UNITED STATES PATENT AND TRADEMARK OFFICE

APPLICATION NO.	FILING DATE	FIRST NAMED INVENTOR	ATTORNEY DOCKET NO.	CONFIRMATION NO.
10/539,036	12/27/2005	Hidehiro Uchiumi	740675-61	5999
22204	7590	01/31/2008		
NIXON PEABODY, LLP 401 9TH STREET, NW SUITE 900 WASHINGTON, DC 20004-2128			EXAMINER MULLINS, BURTON S	
			ART UNIT 2834	PAPER NUMBER
			MAIL DATE 01/31/2008	DELIVERY MODE PAPER

<p align="center">Office Action Summary</p>	Application No. 10/539,036	Applicant(s) UCHIUMI ET AL.	
	Examiner Burton S. Mullins	Art Unit 2834

FIG. 1

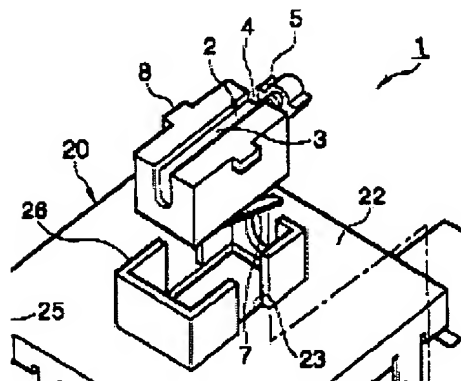
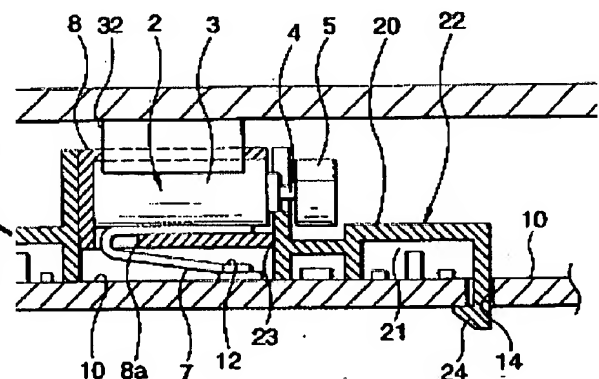
6. Claims 29 and 35 are rejected under 35 U.S.C. 102(a/e) as being anticipated by Sei et al. (US 6,542,381). Sei teaches a vibration motor comprised of a motor body 3 (Fig.1), a motor shaft 4 projecting from the motor body (Fig.2), an eccentric weight 5 attached to the motor shaft 4 (Fig.1), and an attaching means (shock absorber/motor-case) 8 for supporting said motor body 3 in a horizontal prone posture at one surface of a board (base/shield case) 20/22 (Fig.1; see also c.4:35-37 & c.4:48-53 teaching that shock absorber 8 attaches the vibrator by means of a force-fit into holder 26, so that the motor 3 is in a horizontal prone posture at one surface of board 20/22), wherein the attaching means has a pair of attachment faces (not numbered, ‘tabs’ extending from either side of shock absorber/motor-case 8) straddling said motor shaft 4 and

extending in parallel with the same at the two sides of a motor case 8 (Fig. 1; c.4:35-37&48-53) and a plane including said pair of attachment faces intersects with a circular orbit of the outermost point of the eccentric weight 5 at two points (i.e., a plane passing through 'tabs' inherently intersects with a circular orbit of the outermost point of eccentric 5 at two points on the plane since the eccentric 5 including its outermost point rotates through the plane, perpendicularly to it, as seen in Figs.1&2, and thus intersects with the plane at two points).

Regarding claim 35, the attachment faces (tabs or shock absorber/motor case 8) are shaped such that they can be considered "rails" (Fig.1).

8. Claims 30 and 36 are rejected under 35 U.S.C. 103(a) as being unpatentable over Sei et al. In Fig.1, Sei does not specify that the pair of attachment faces/tabs are positioned closer to the eccentric weight 5 than to a center of gravity of said vibration motor. However, merely repositioning the faces 8 would have been obvious since it has been held that shifting location of parts involves routine skill. In re Japikse, 86 USPQ 70.

Regarding claims 34 and 40, Sei's attachment means (shock absorber/motor case) 8 comprises attachment faces/tabs extending from both sides at the top thereof (not numbered, Fig.1). With this in mind, it cannot be deduced from Fig.2 that the attachment faces/tabs "[affix] to one surface of said board at the sides of said cutaway space or said open space, and

said vibration motor is mounted with at least said motor body in a state sunken in said cutaway space or said open space” since it appears that the attachment faces/tabs would be located some distance above the surface of the circuit board (base/shield case) 20/22.

12. Regarding the rejection over Sei et al. (US 6,542,381), the examiner notes that the “shock absorber” 8 comprises a ‘housing’ or ‘case’ as applicant argues; however, it also comprises ‘tabs’ (applicant’s term) which extend from its side. Although not numbered, these ‘tabs’ are clearly shown in Fig.1 (they are also shown in Prior Art Fig.3A as part of the “shock absorber” 51). Drawings and pictures can anticipate claims if they clearly show the structure which is claimed. *In re Mraz*, 455 F.2d 1069, 173 USPQ 25 (CCPA 1972). The ‘tabs’ comprise “attachment means” since they are part of the “shock absorber” 8 disclosed as attaching the vibrator by means of a force-fit into holder 26, so that the motor 3 is in a horizontal prone posture at one surface of board 20/22 (c.4:35-37). Further, as can be readily seen in Fig.1, the tabs slide into respective slots (not numbered) on either side of holder 26 in which the vibrator is “forced” and “held” (c.4:35-37). Sei teaches that the walls of the holder are formed in

a box shape and “hold the vibrator forced into the holder in such a manner that the vibrator does not move up and down and left and right” (c.4:48-53). Thus, the “shock absorber” 8 and the ‘tabs’ forming a portion thereof comprise “attachment means”.
